In Re the Application of: Marcos C. Tzannes)	Group Art Unit: 2465
Application No.: 12/783,777)	Examiner: HO, Duc Chi
Filed: May 20, 2010)	Confirmation No.: 7487
Atty. File No.: 5550-16-CON-3)

For: SYSTEMS AND METHODS FOR MULTI-PAIR ATM OVER DSL

AMENDMENT AND RESPONSE

Fig. 16

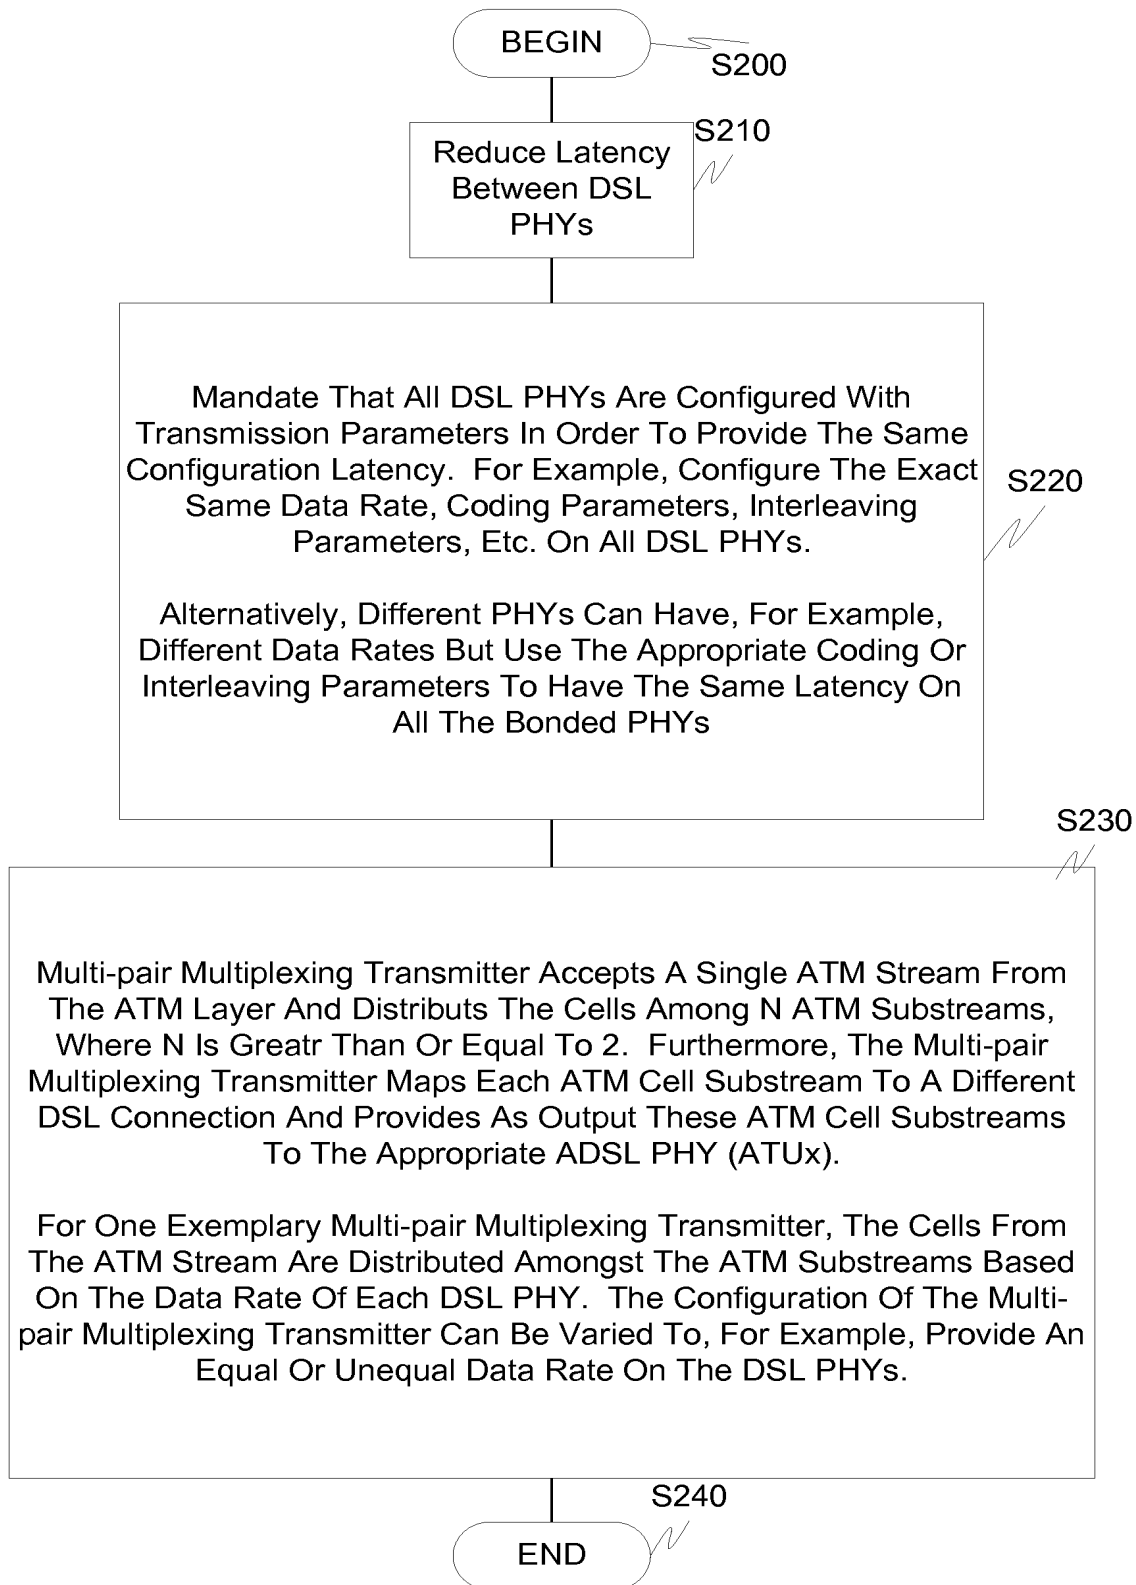
1. The drawings are objected to under 37 CFR 1.83(a). The drawings must show every feature of the invention specified in the claims. Therefore, the steps in claim 15 must be shown or the feature(s) canceled from the claim(s). No new matter should be entered.

Corrected drawing sheets in compliance with 37 CFR 1.121(d) are required in reply to the Office action to avoid abandonment of the application. Any amended replacement drawing sheet should include all of the figures appearing on the immediate prior version of the sheet, even if only one figure is being amended. The figure or figure number of an amended drawing should not be labeled as “amended.” If a drawing figure is to be canceled, the appropriate figure must be removed from the replacement sheet, and where necessary, the remaining figures must be renumbered and appropriate changes made to the brief description of the several views of the drawings for consistency. Additional replacement sheets may be necessary to show the renumbering of the remaining figures. Each drawing sheet submitted after the filing date of an application must be labeled in the top margin as either “Replacement Sheet” or “New Sheet” pursuant to 37 CFR 1.121(d). If the changes are not accepted by the examiner, the applicant will be notified and informed of any required corrective action in the next Office action. The objection to the drawings will not be held in abeyance.

The attached drawing sheet(s) include(s) new Figure 16.

By this amendment, new Fig. 16 has been added that, as requested by the Examiner, includes the steps of claim 15. Literal and direct support for this figure can at least be found in paragraphs 52, 6, 39, 40, 43 and 44 of the originally filed specification.

[0082] Fig. 16 is a flowchart illustrating an exemplary method for reducing latency between DSL PHYs. Control begins in step S200 and continues to Step S210. In Step S220, and as discussed, another effective method of reducing the difference in latency between DSL PHYs is mandate that all DSL PHYs are configured with transmission parameters in order to provide the same configuration latency. An exemplary method of accomplishing the same configuration latency is by configuring the exact same data rate, coding parameters, interleaving parameters, etc. on all DSL
